INSTRUCTION TO SERVICE

| ITS: 60352 | | DATE 06/04/2024 |
| SUBJECT: | Infotainment Monitor Support Bracket Installation | |
| SUMMARY: | R&R Infotainment Sign Bracket Hardware with Shorter Hardware | |

Figure 1: Single mounted sign bracket location reference.

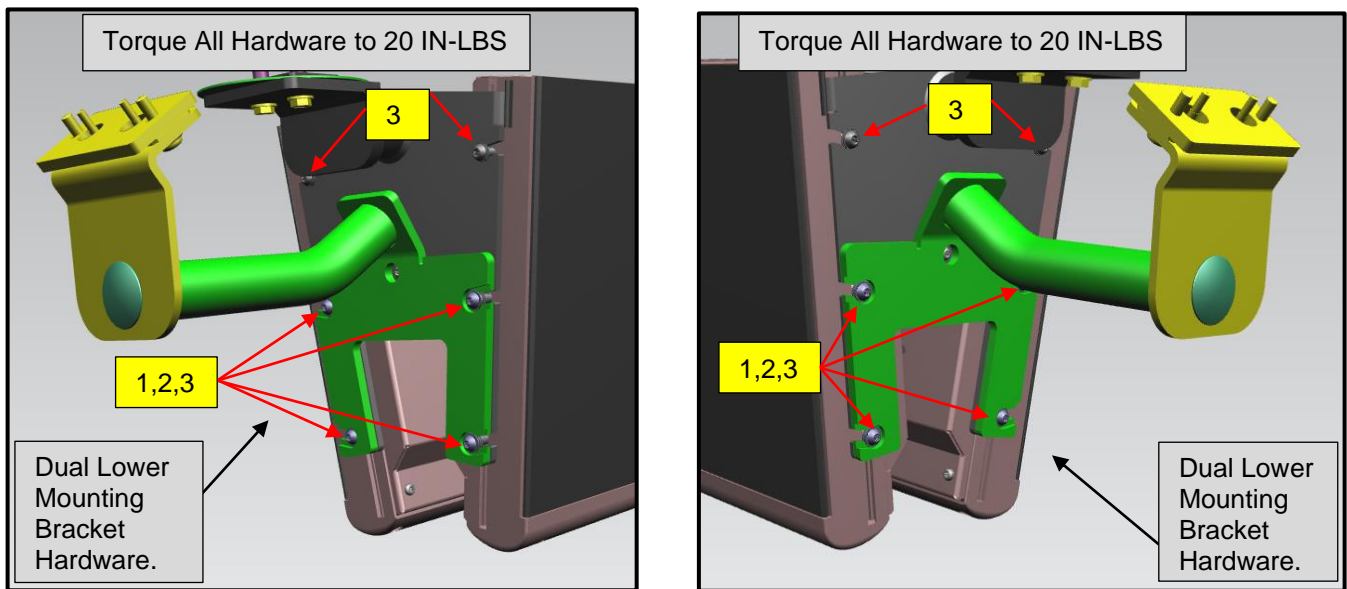
1. Ensure to apply parking brake.
2. Turn the main battery disconnect switch to the “OFF” position.
3. Locate the infotainment sign(s). See Figure 1.
4. Locate the single mounted signs bracket hardware and remove the four lower mounting screws and washers one at a time and replace them with new item #1 Screws and item #2 Washers. Apply one or two drops of Loctite item #3 to their threads and torque to 20 IN-LBS. See Figure 1. Discard old screws and washers.

🔧 **NOTE: Only remove one screw at a time not to allow the internal nut in the sign to slide downward.**
5. Locate the two upper sign mounting screws and washers. Remove them and apply one or two drops of Loctite the screw threads re-installing and torque to 20 IN-LBS. See Figure 1.
